R.E. Ginna Nuclear Power Plant

**Response to NRC Generic Request for Additional Information Regarding
Relaxed Axial Offset Control, R.E. Ginna Nuclear Power Plant (TAC No.
MC6867)**

**RESPONSE TO NRC REQUEST FOR ADDITIONAL INFORMATION
REGARDING RELAXED AXIAL OFFSET CONTROL, R.E. GINNA
NUCLEAR POWER PLANT**

Figure 1 (F_Q Results from Most Limiting Representative LP)

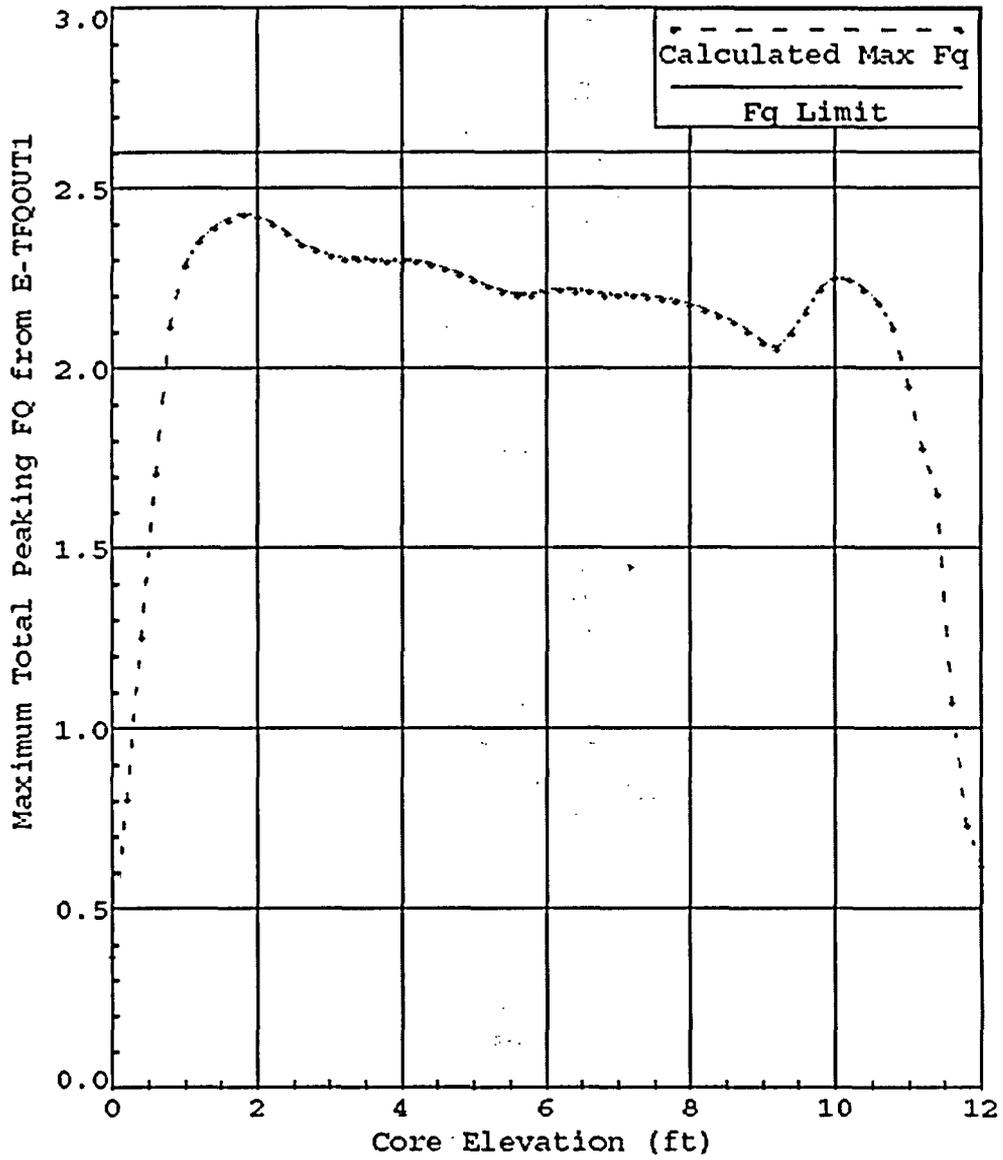
Provide the results of the F_Q analysis (i.e., the permissible F_Q and the $W(Z)$ function).

As described in the response to RAI #1, the analysis performed for Ginna was based on representative uprated loading patterns, and a specific reload analysis will be performed for each reload to check the applicable limits. The requested results from the most limiting representative loading pattern studied for Ginna are shown in Figures 1 and 2. These results correspond to the typical AFD band limits identified in the response to RAI #1. The maximum transient F_Q result for the limiting representative cycle was 2.432, compared to a LOCA limit of 2.60. These results only confirm the viability of the methodology and should not be used as a defining basis for NRC approval. As described in the 29 April 2005 application, the actual determination of the permissible F_Q and the $W(Z)$ values is performed for each reload cycle.
